ORDER UNDER SECTION 96 (2) OF ACT, III OF 1901.

Re: Bungalows on plot No. 15 & 16, C.L.6, Civil
Lines Quarters.

PROPOSED BUNGALOW
ON PLOT NO 15 & 16 SHEET NO C.L. 6
CIVIL LINES QUARTER
SCALE 8 FEET TO AN INCH

AMENDED PLAN FOR PROPOSED DUNGALOW ON PLOT NO 15 & 16 SHEET NO C.L.6

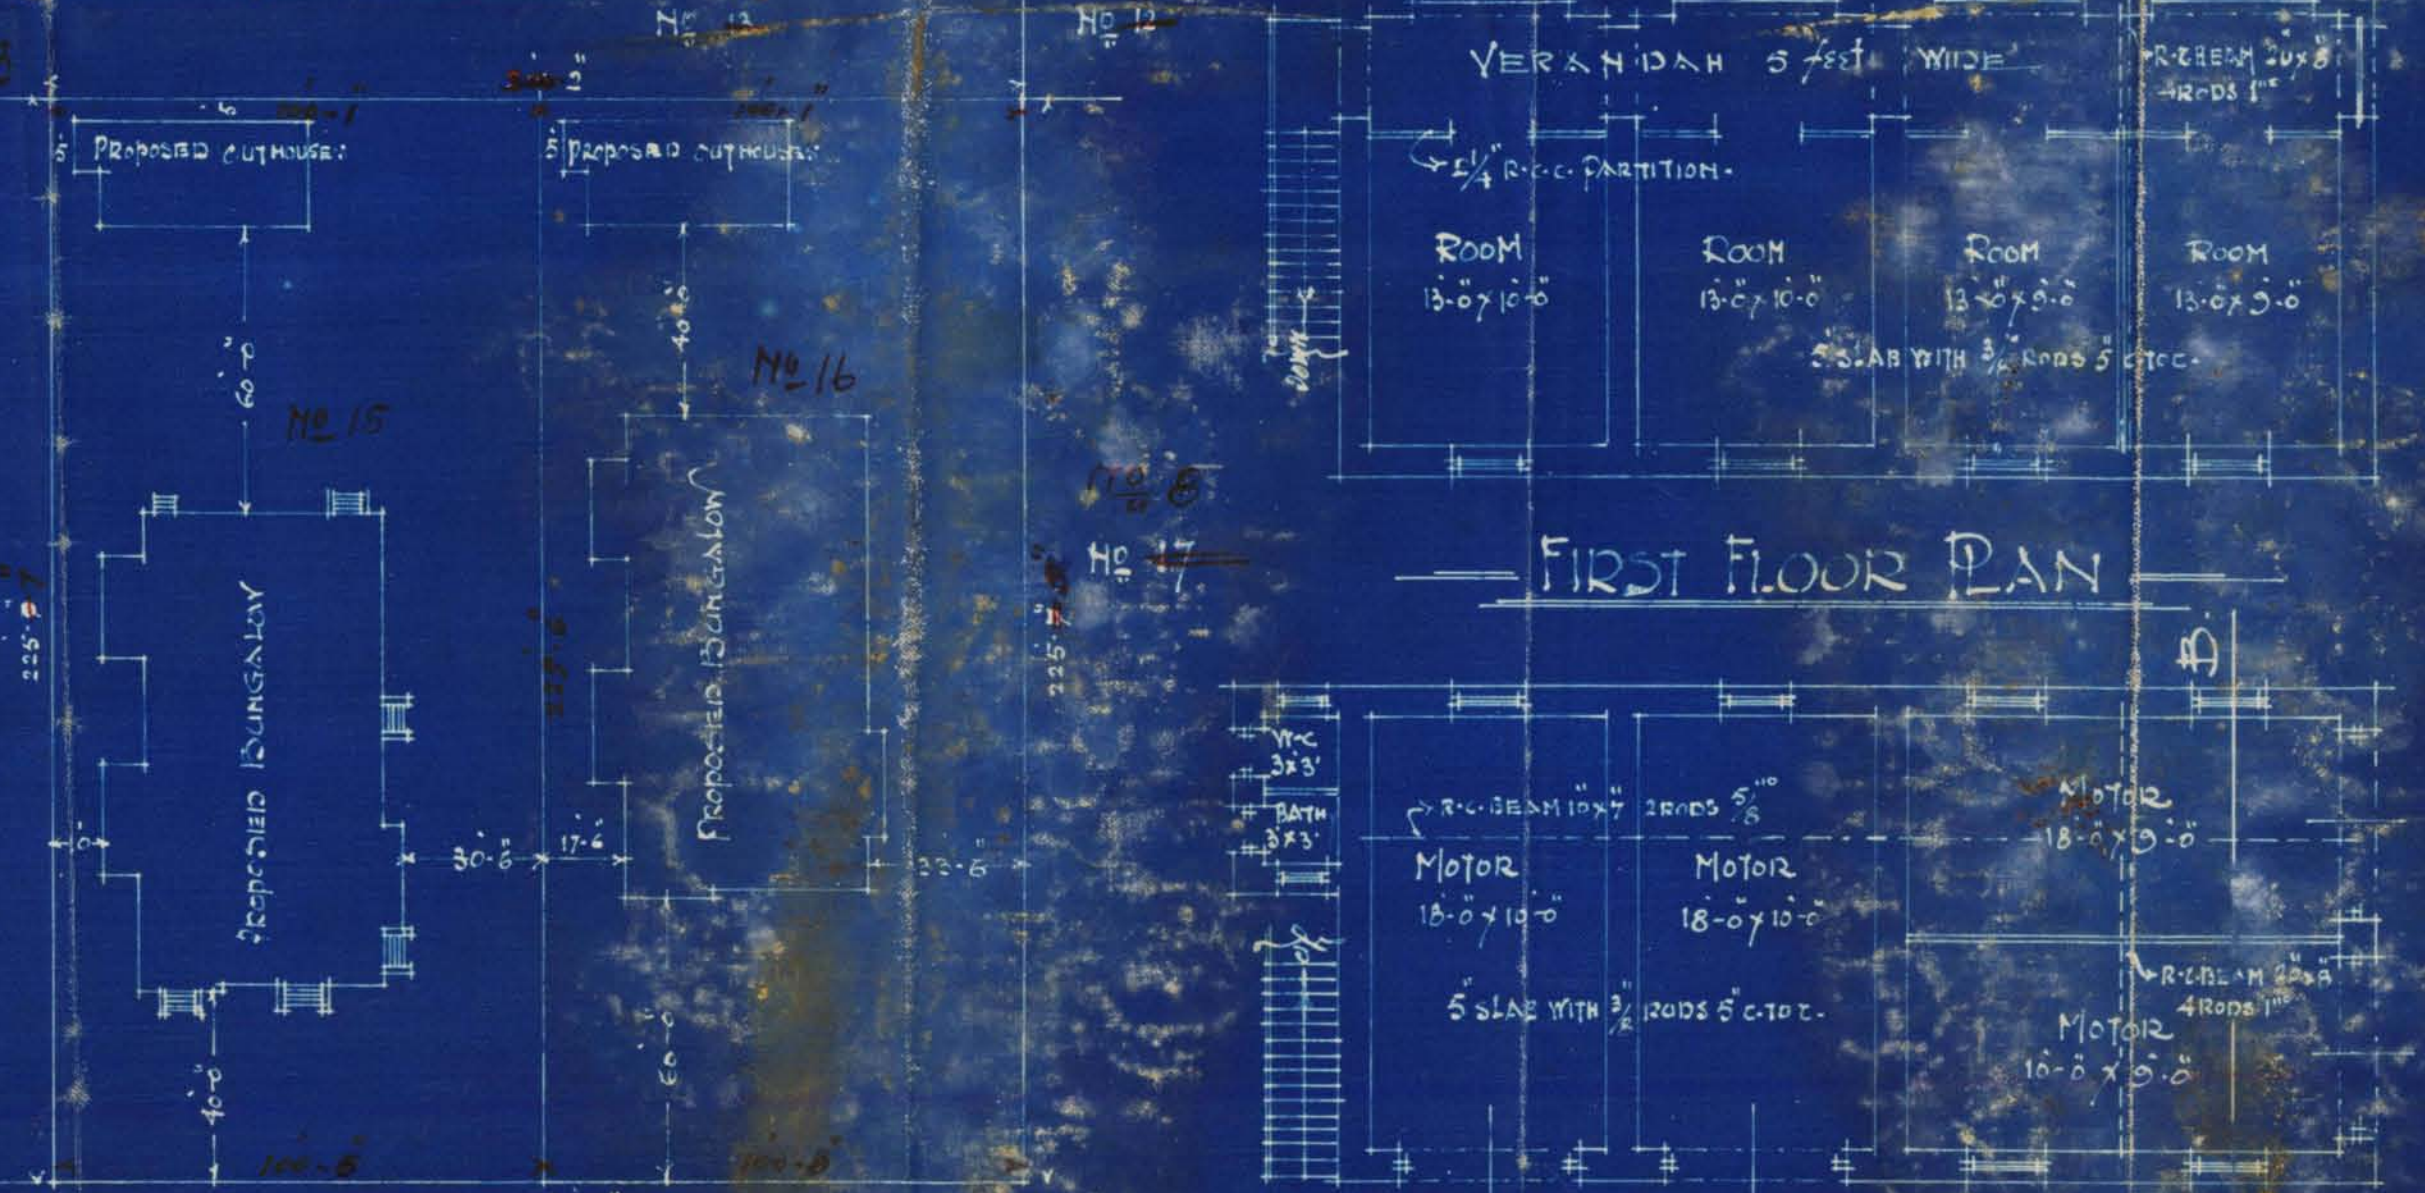
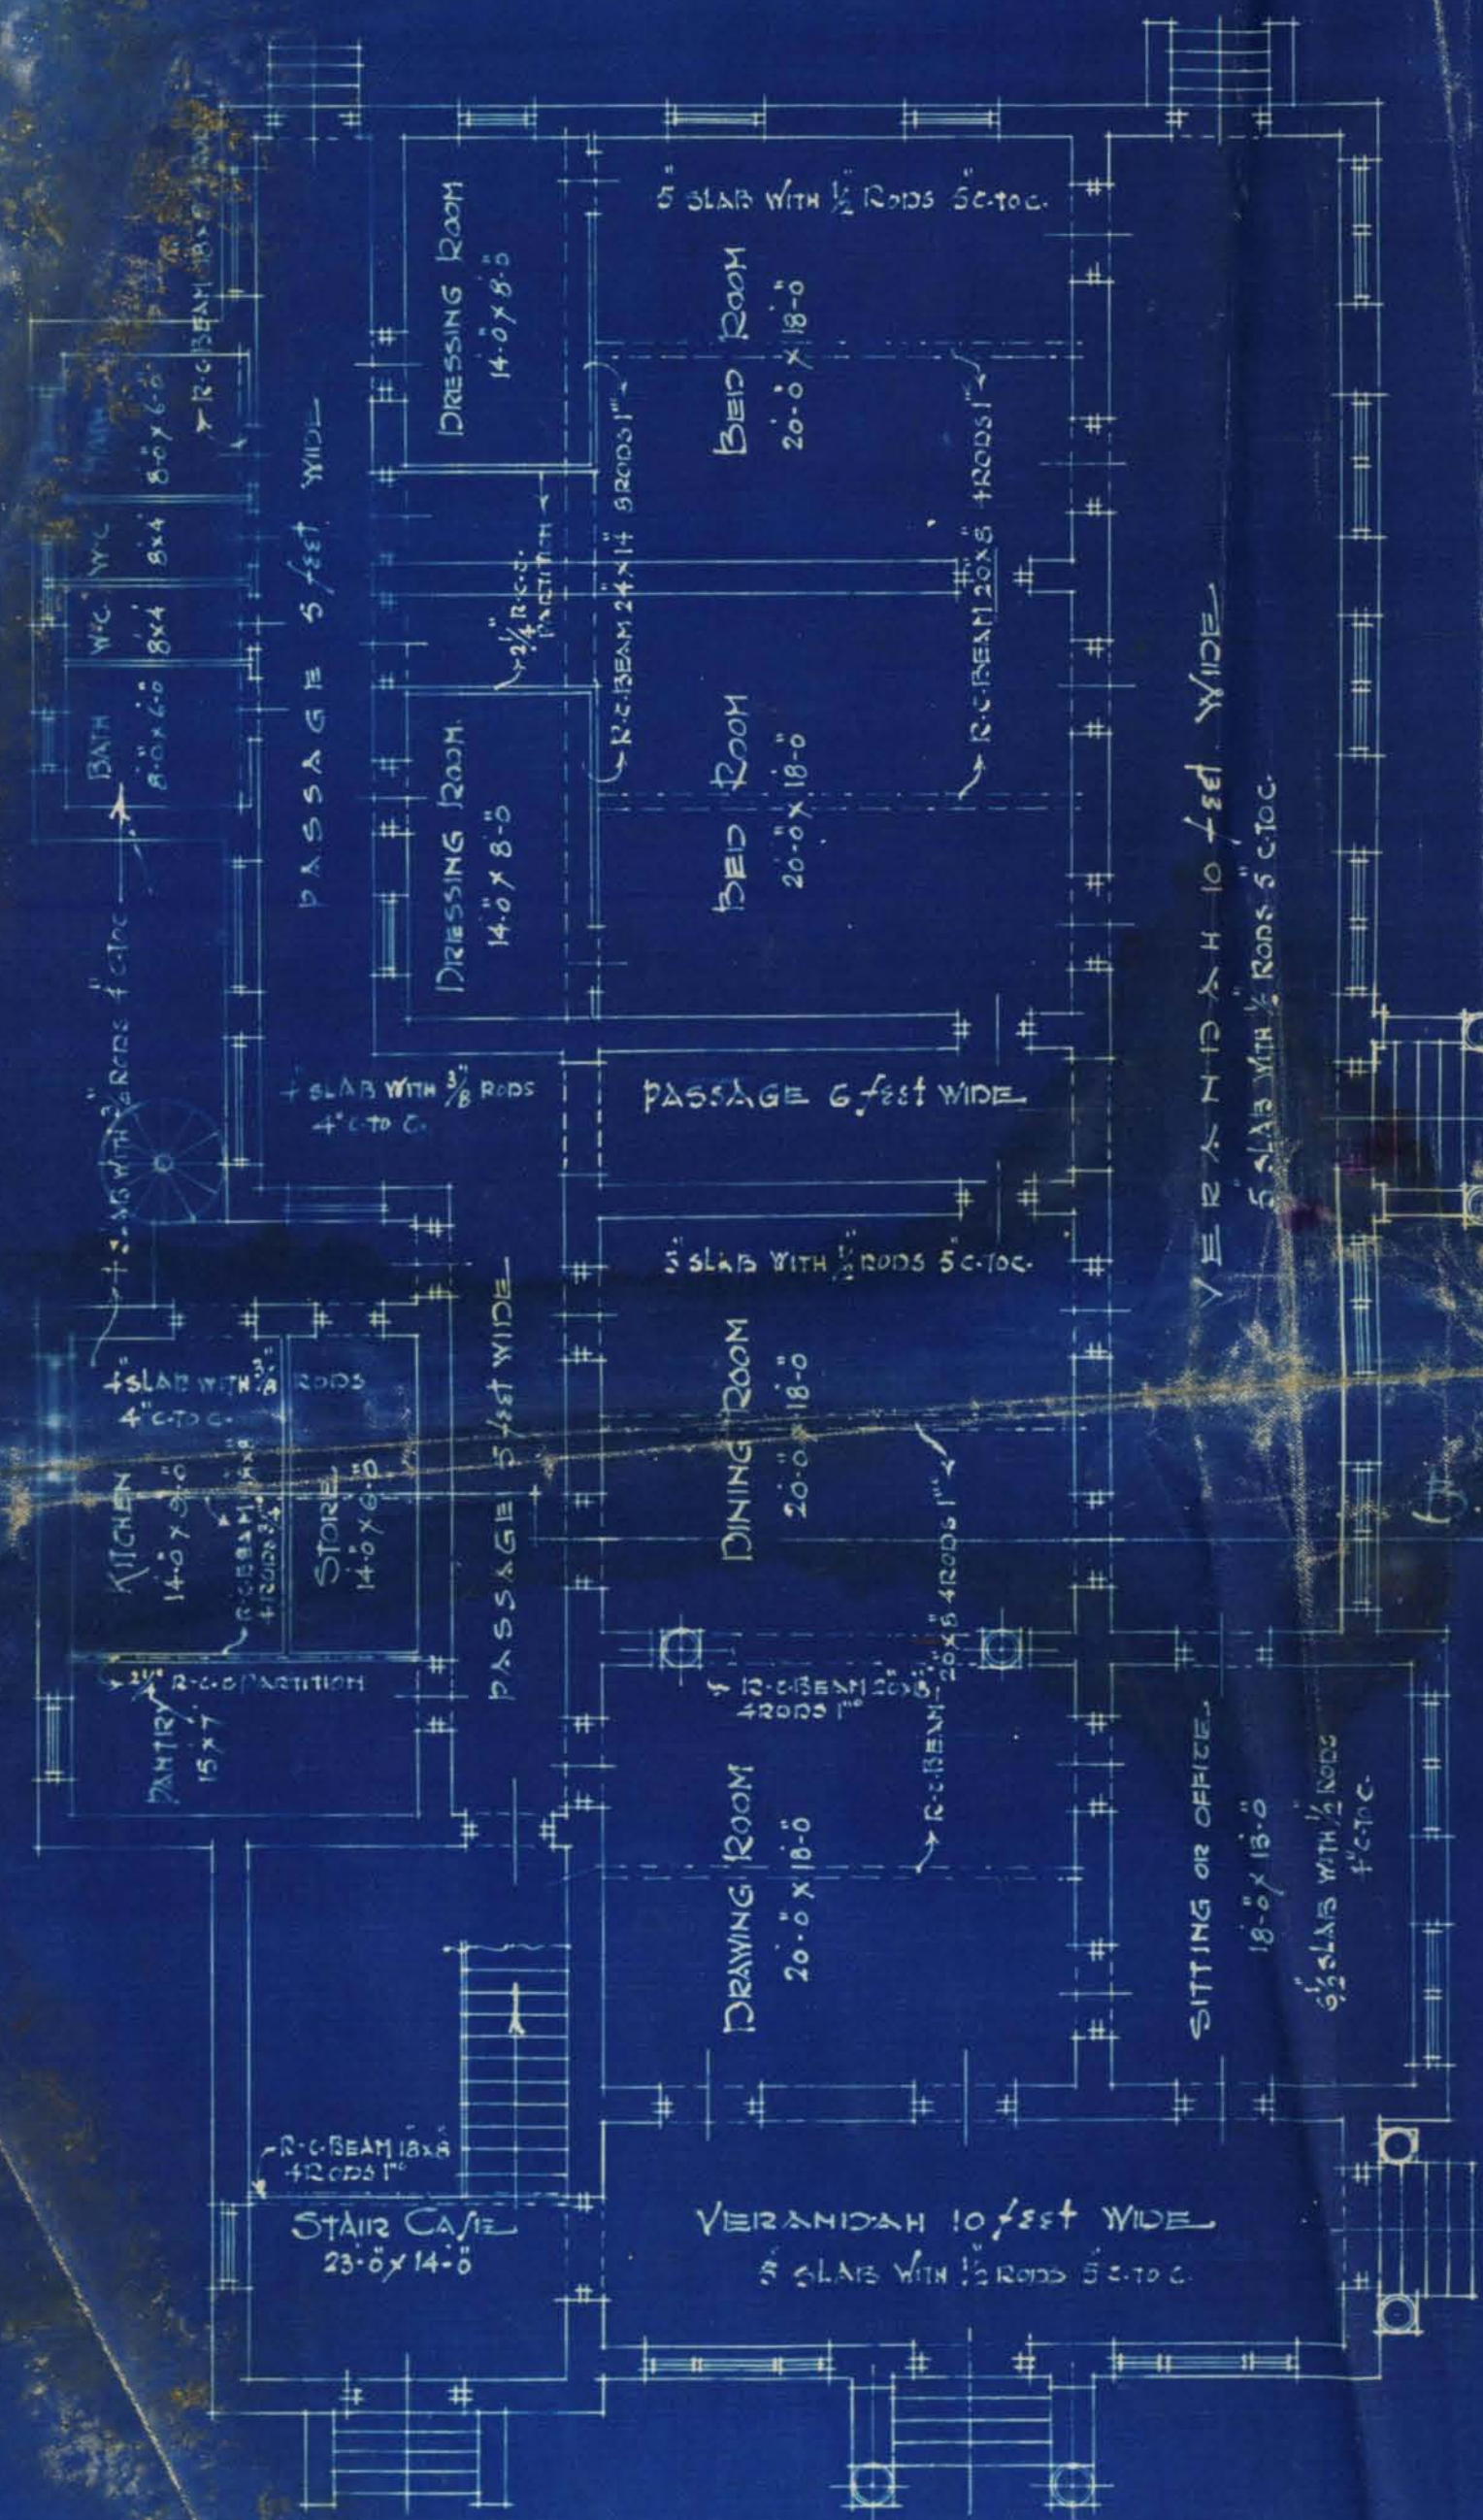
- (1) Title deed must be produced as the plots do not stand in the applicant's name
- (2) measurements of the plots must be written separately
- (3) Calculations of R. C. work are required. 4 rods for 20' span are insufficient
- (4)
- (5)
- (6)
- (7)
- (8)
- (9)

① Title deed must be produced

② Stab of the stair case room should be specified

③ Foundations on plot no. 15 are already lined out on site.

④ Two separate bungalows on separate plots are shown on only one plan.

① Please put up calculation of area, ②
about the deeds and the C.D.C. if necessary
BS ① measuring plots and the
making separate calculation of RB
Work is required for 20' bearing is insufficient

With reference to your memo No. L.M.A. IO233 dated 18th inst, re buildings in plot No/ I5 & I6 C.L.6, we beg to state as under.

(1) The Plots are transfered in the name of our client Mr. Fakirji Cavasji on 27th July 1928, and the Sanads are with the City Deputy Collector.

(2) The measurments of the plots are shewn on the plans.

(3) The beam for 20' span of 20"x8" with 4 rods I" is good enough for 22.3 tons (B.R.C. Fabric hand book table 8) where as ^{The} ~~the~~ actual load will be only 11.2 tons.
